SUNDRY NOTICES AND REPORTS ON WELLS (DO NOT USE THIS FORM FOR PROPOSALS TO DRILL OR TO DEEPEN OR PLUG BACK TO A DIFFERENT RESERVOIR. USE "APPLICATION FOR PERMIT" (FORM C-101) FOR SUCH PROPOSALS.)		WELL API NO. 30-015-56186
1. Type of Well: Oil Well ☒ Gas Well ☐ Other ☐		5. Indicate Type of Lease STATE ☒ FEE ☐
2. Name of Operator DEVON ENERGY PRODUCTION COMPANY, LP		6. State Oil & Gas Lease No.
3. Address of Operator 333 W SHERIDAN AVE OKLAHOMA CITY, OK 73102		7. Lease Name or Unit Agreement Name MIMOSA 17-16 STATE COM
4. Well Location Unit Letter <u>F</u> : <u>1400</u> feet from the <u>NORTH</u> line and <u>2196</u> feet from the <u>WEST</u> line Section <u>18</u> Township <u>20S</u> Range <u>30E</u> NMPM County <u>EDDY</u>		8. Well Number 221H
11. Elevation (Show whether DR, RKB, RT, GR, etc.) 3276		9. OGRID Number 6137
		10. Pool name or Wildcat PARKWAY; BONE SPRING (49622)

Devon Energy Production Company L.P. respectfully requests the following changes to the approved APD:

Break test and offline cementing variance request.

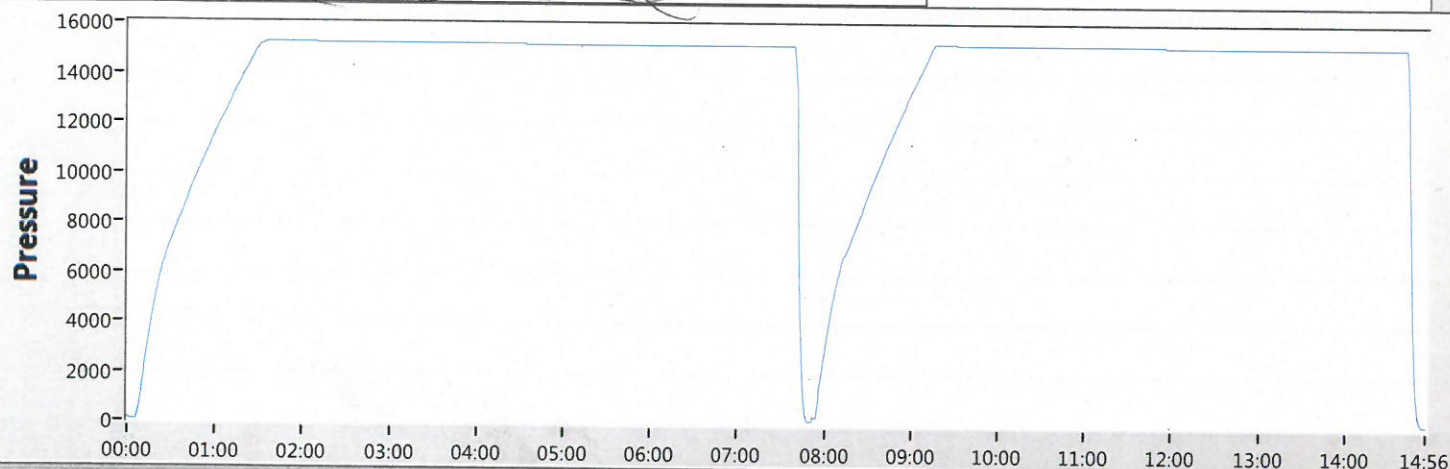
Devon requests Break testing as stated above for 5K tests, not including production hole

Annular Preventer will be tested to minimum of 70% RWP and higher than MASP during initial BOP test

Pressure testing is required for pressure-containing connections if the integrity of a pressure seal is broken during a break test

Full Tests required when entering production hole
